Subject: Response to Comments in SCDHEC Letter Titled, "Reviews of Requests for Injection Wells, Pumping of Monitoring Wells and Monthly Status Reports", dated June 26, 2018
Plantation Pipe Line Company
Lewis Drive Remediation Site
Belton, South Carolina
Site ID #18693, "Kinder Morgan Belton Pipeline Release"

Figure 1. Proposed Biosparging System Expansion Layout
 Lewis Drive Remediation Site
 Belton, South Carolina
 Site ID #18693 "Kinder Morgan Belton Pipeline Release"

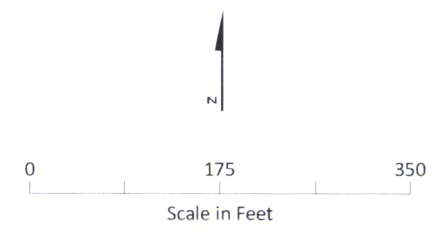
Comment 1: *The Department suggests that additional monitoring wells be proposed west of the requested sparging wells in the area between MW-36 and MW-21 to measure the effectiveness of the supplemental sparging in the area of Cupboard.*

Response: Plantation believes that no additional monitoring wells are necessary to measure the effectiveness of the supplemental sparging in the subject Cupboard Creek area. Current monitoring well MW-21 serves this purpose. One additional monitoring well (MW-55) is proposed to be installed west of monitoring well MW-36 to establish a clean perimeter, since dissolved petroleum concentrations have been detected in MW-36 (see Figure 1).
